# **Prelude Floating LNG Project EIS Supplement-Response to Submissions**

**Shell Development (Australia) Proprietary Limited  
EPBC 2008/4146**

**January 2010**

**Figure 6.18** GHG Intensity Comparison

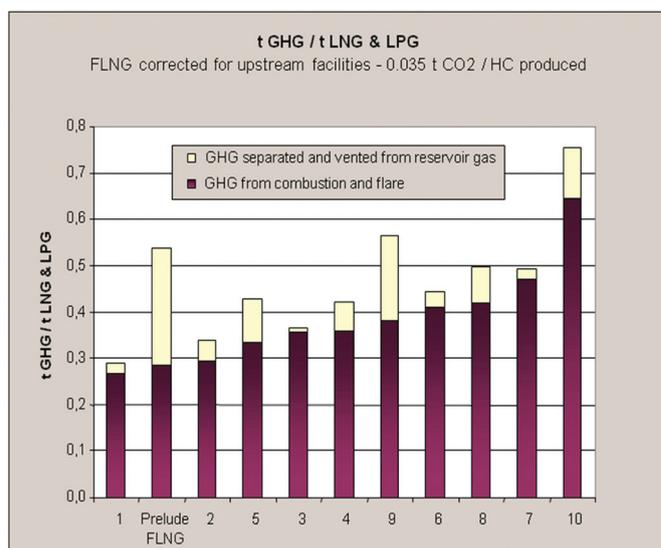
Reference Number	Submission Party	Issue Raised
4	Ari Chakrabarti	In EIS for recent LNG projects in Australia, benchmarked comparison has been presented, and it shows specific names of each project. For Prelude project, similar comparison should be presented also.

Reference Number	Submission Party	Issue Raised
3	Ari Chakrabarti	Draft EIS Figure 6.18 shows comparison of GHG intensity for a group of 10 existing world scale LNG facilities benchmarked against the Prelude FLNG facility. However, it is not clear how the figures of 10 existing facilities have been estimated. The detailed calculation basis, including amount of subtracted as upstream operation, should be elaborated.

Figure 6.18 of the Draft EIS was presented to enable comparison of Prelude’s Green House Gas (GHG) intensity with similar projects (benchmarking). This was also a requirement as stipulated in DEWHA’s Prelude EIS guidelines (See Appendix A of the Draft EIS). A copy of Figure 6.18 from the Draft EIS is also presented below.

Benchmarking is a process which enables comparison of a chosen performance metric (GHG intensity in this case) between different projects. Each participant is able to see how they compare to their peers whilst their own specific performance is kept confidential from the other participants. Shell is not able to publicly name the 10 other facilities included in the GHG intensity comparison presented in Figure 6.18 of the Draft EIS, as they are confidential. Prelude’s GHG intensity can still be compared and ranked without the inclusion of facility names.

As shown in Figure 6.18 and discussed in detail in Section 6.8.2 of the Draft EIS, the FLNG liquefaction process is energy efficient but Prelude’s higher reservoir CO<sub>2</sub> levels contribute to its GHG footprint. See also the response to Submission Reference Number 7 presented in Section 2.3.5 of this document for further discussion of Prelude’s GHG intensity compared to other proposed LNG projects.

The data used in Figure 6.18 of the Draft EIS was based on results of a benchmarking study undertaken by Shell Global Solutions International using their proprietary methodology which was designed to ensure a “like-for-like” comparison. For calculating the CO<sub>2</sub> emissions from each participant, the following data is requested:

The upstream GHG intensity for Prelude was derived from the energy usage of more than 100 Shell upstream facilities across the globe over a number of years. It is an average figure only and was subtracted from the overall FLNG GHG intensity result to allow a direct comparison between the Prelude FLNG Facility and onshore LNG plants (which excluded the upstream energy usage).
